<b>Company</b>	Trenz Electronic GmbH
<b>PCN Number</b>	PCN-20190111
<b>Title</b>	TE0841-02-* SPI Flash Change
<b>Subject</b>	BOM change
<b>Issue Date</b>	2019-07-15

This change affects all Trenz Electronic TE0841-02 SoMs: TE0841-02-\*

Locate Flash (U6) on top side of PCB:

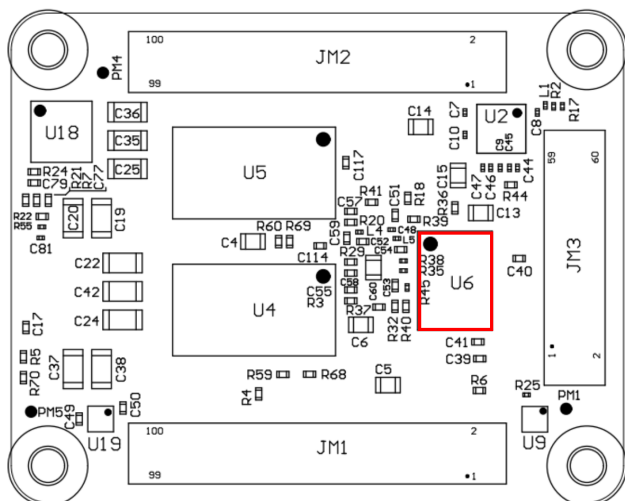
### #1 Change SPI Flash from N25Q512A11G1240E to MT25QU512ABB8E12-0SIT

**Reason:** N25Q512A11G1240E became obsolete.

**Impact:** None. Both have same JEDEC ID BB20h and manufacturer ID 20h.

old	new
<b>N25Q512A11G1240E</b>	<b>MT25QU512ABB8E12-0SIT</b>
